Project Number: O-E8982-00-04

RE: Public review comments on the Environmental Report for the Enerdu GS Expansion and Redevelopment Project

Figure 1. Zones of influence – EA vs. current operations at the Enerdu GS

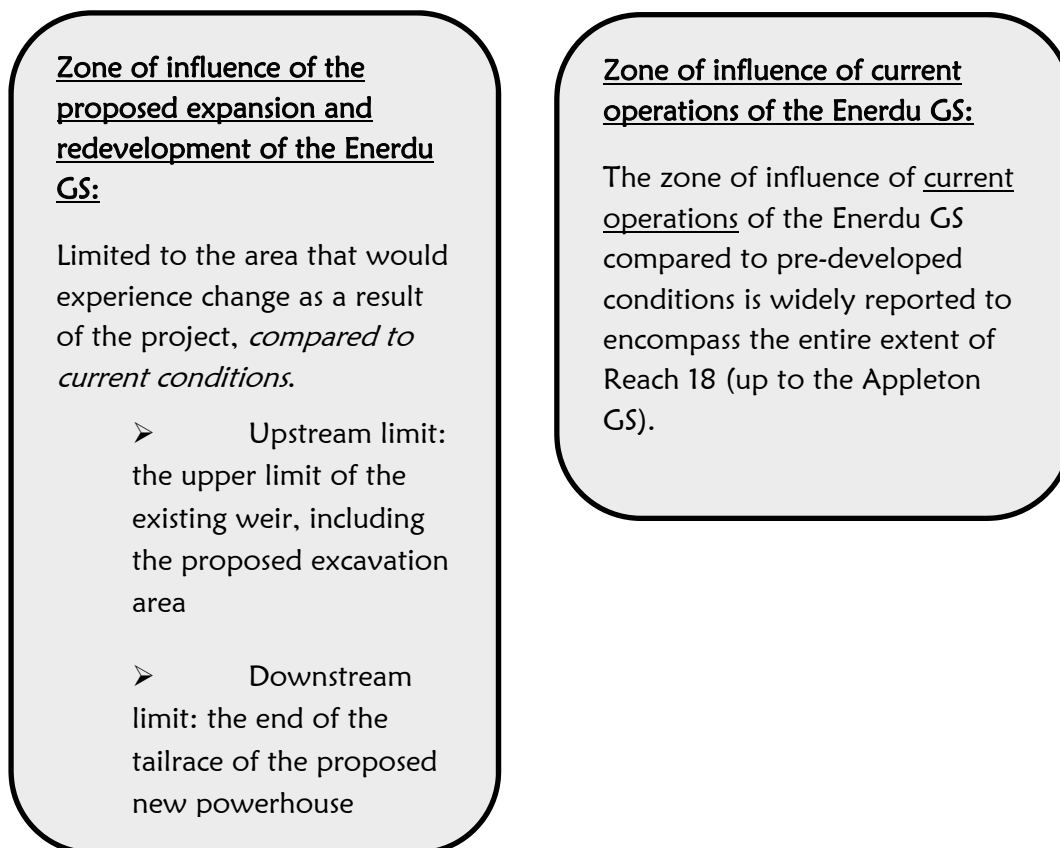
We would like to clarify at the outset the confusion over the purpose and scope of the environmental assessment (EA), the findings of which are presented in the Final Environmental Report.

The EA is intended to assess the potential impacts associated with the proposed expansion and redevelopment of the Enerdu GS; that is, *existing conditions* were compared to what may occur if the project proceeds. Since the proposed upgraded facility would continue to adhere to the Mississippi River Water Management Plan (MRWMP) as it currently exists, no changes to water levels between the Enerdu GS and the Appleton GS (i.e. Reach 18) would occur as a result of the proposed project redevelopment. The zone of influence of the proposed project itself therefore spans from the proposed excavation area near the upper limit of the existing weir, down to the tailrace of the proposed new powerhouse. Since the scope of the EA focused on the areas that would experience change due to the proposed project, the study area for the EA (including the natural heritage component of the EA) was generally focused on the immediate project area, rather than extending 9 km upstream to include the Appleton wetland and the tailrace of the Appleton GS and 15 km downstream to include the Galetta GS.

Figure 1 illustrates the difference between 1) the Zone of Influence of the proposed Enerdu project and 2) the Zone of Influence of current operations at the Enerdu GS compared to pre-developed conditions.
